STATE OF HAWAII  
DEPARTMENT OF LAND AND NATURAL RESOURCES  
**COMMISSION ON WATER RESOURCE MANAGEMENT**  
P.O. BOX 621  
HONOLULU, HAWAII 96809

**NOTICE OF ALLEGED VIOLATION**  
Interim Instream Flow Standard and Failure to Follow Through  
With Commission Order from November 20, 2019  
Honokōhau Stream, Honokōhau, Maui

Re: CDR.5095.6

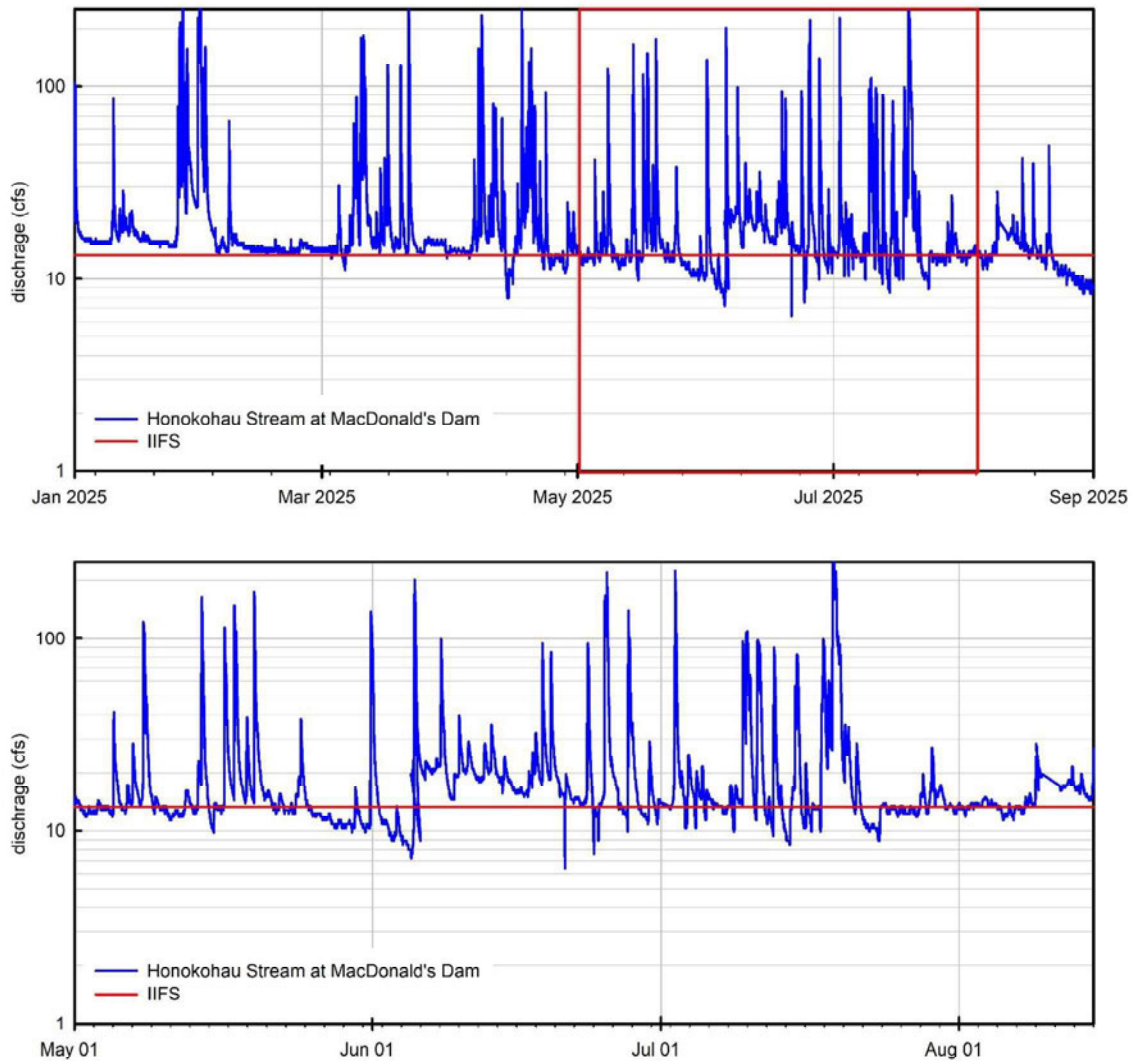
According to Commission gaging records at station 6-149, from January 1, 2025 to August 14, 2025 (225 days), there were 36 days (16.0%) where the mean daily flow on Honokōhau Stream, measured at MacDonald's Dam, was below the interim IFS (Figure 1). Those dates are identified in Table 2, with the mean daily flow measured at U.S. Geological Survey station 16620000 on Honokōhau Stream and at Aotaki Weir on Honokōhau Stream.

Based on measured streamflow values, there is sufficient water to meet the interim IFS if the USGS 16620000 station reads at least 9.9 cfs (6.4 mgd) and no water is diverted out of Honokōhau Stream due to the groundwater gains in streamflow between USGS 16620000 and Aotaki Weir (Table 3) and the groundwater gains between Aotaki Weir and MacDonald's Dam (Table 4). On the date of each violation, there was sufficient water in Honokōhau Stream above Aotaki Weir to meet the interim IFS (Table 2). Commission staff communicated with the ditch operator on May 28, 2025, July 8, 2025, July 23, 2025, and July 27, 2025 regarding non-compliance with the interim IFS.

Regarding the first alleged violation, we expect MLP to take immediate steps to ensure compliance with the interim IFS on Honokōhau Stream.

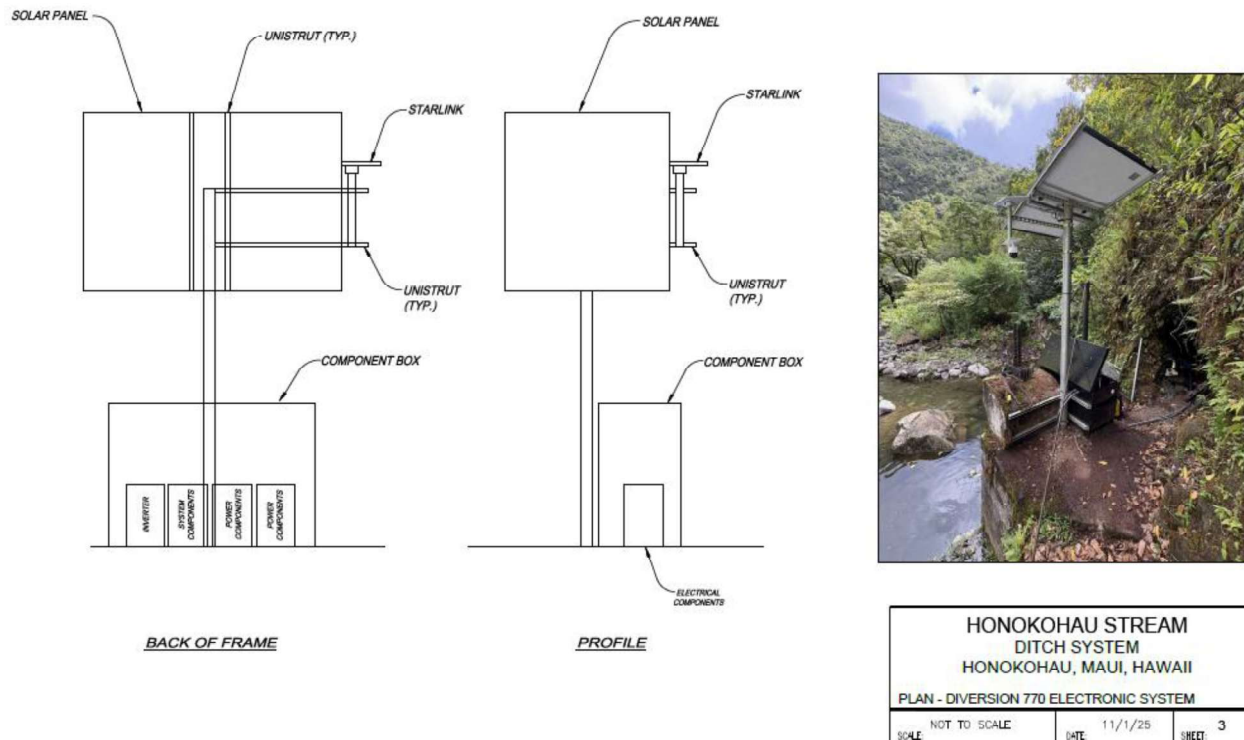
Although no longer required by the Amended Order, in October 2025, and in coordination with CWRM staff, the remotely operated gate at Diversion 770 was installed.<sup>2</sup> The gate controls the quantity of water that enters the Ditch,<sup>3</sup> thereby significantly reducing the volume of water entering the Ditch during low flows and keeping more water flowing the full length of the Stream. MLP believes that remote operation and monitoring will allow faster response times and more nuanced adjustments in response to low streamflow to maintain the IIFS.

<sup>3</sup> As designed, the remotely operated gate at Diversion 770 eliminates the need for low and high flow restrictor plates to meet the IIFS. MLP intends, however, to keep the restrictor plates to further assist with reducing debris in the Ditch.
